Date : 20-Mar-2023

Reg. Ref. : SD21A/0350/C4
Proposal : Retention of constructed fence and boundaries and the relocation of existing access gate to revised location and proposed use of space as an allotment.
Condition 4; Boundary Treatment
Within 6 months of the date of final grant of permission the applicant shall submit for the written agreement of the Planning Authority revised scaled drawings clearly showing the replacement of this proposed palisade fence that will be offset 3 metres from the southern site boundary with a new visually improved fence which shall take the form and height of what currently exists at the interface with the public footpath i.e. green weld-mesh/paladin type fencing system.
REASON: In the interest of proper planning and sustainable development

Location : Long Mile Road, Drimnagh, Dublin 12
Applicant : Noel Whelan
Application Type: Compliance with Conditions

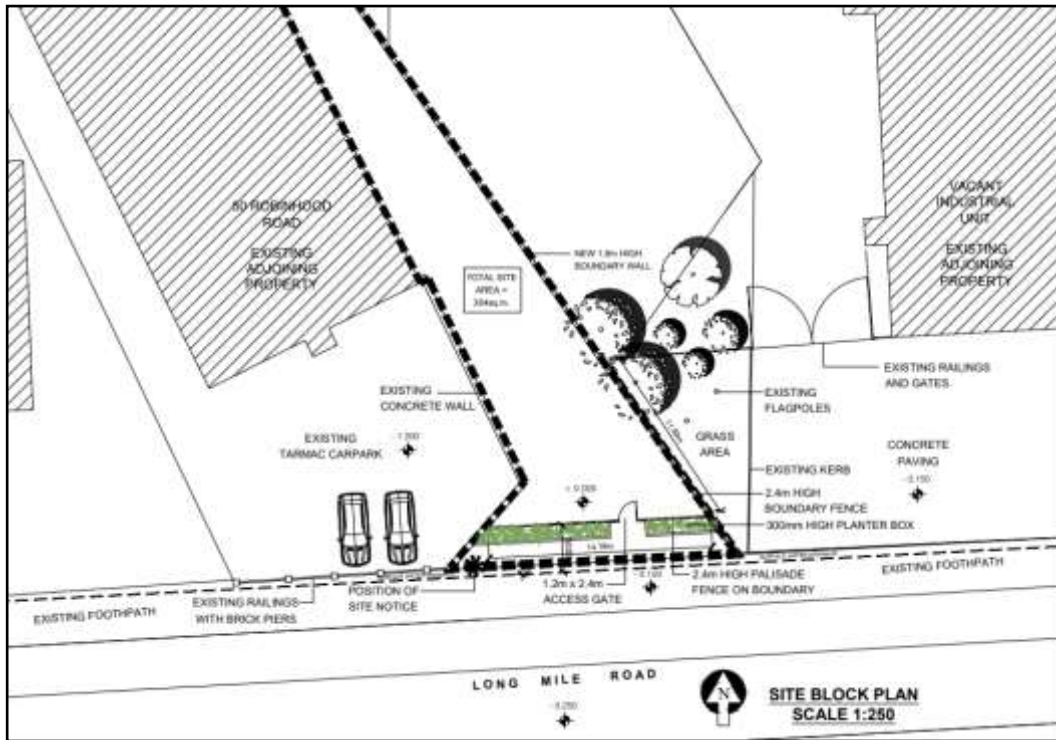
The applicant has submitted revised drawings that indicate that the proposed palisade fence is offset by 3m from the southern site boundary and images show a green weld-mesh fencing system has been installed. See image below.

Regarding the revised drawings submitted by the applicant, both drawings show the fencing to be offset by 3m, however this measurement does not appear to be from the southern site boundary as requested in the above condition. In addition, the site inspection confirmed the distance to be below 2.5m from the southern site boundary.

In regard to the photos submitted by the applicant, they show the offset area covered in artificial grass. However, as mentioned on the day of inspection, this artificial grass shown was already pulled back and showed some potential safety concerns for the users of the public footpath.

In reference to condition 2 associated with this application, it is stated that; *Kerbing shall not be dished at this location.* The above images show the dished kerbing, and it is also covered with artificial grass. The applicant should remedy this public hazard safety concern as it could cause trips and slips. The photos submitted by the applicant also show planter boxes in situ, it is noted that on the day of inspection these were removed.

Regarding the applicants attempt of offsetting the palisade fencing, the above images show a below standard of works to the southern site boundary. This boundary interfaces directly with the public footpath. The applicant is advised to have regard to a sensitive design approach and ensure there are no public hazard concerns, and ensure any works are complementary to the surrounding streetscape and not visually obtrusive for users of this public footpath.

The applicant is strongly advised to have regard to Condition 2 when re-submitting a compliance for Condition 4.
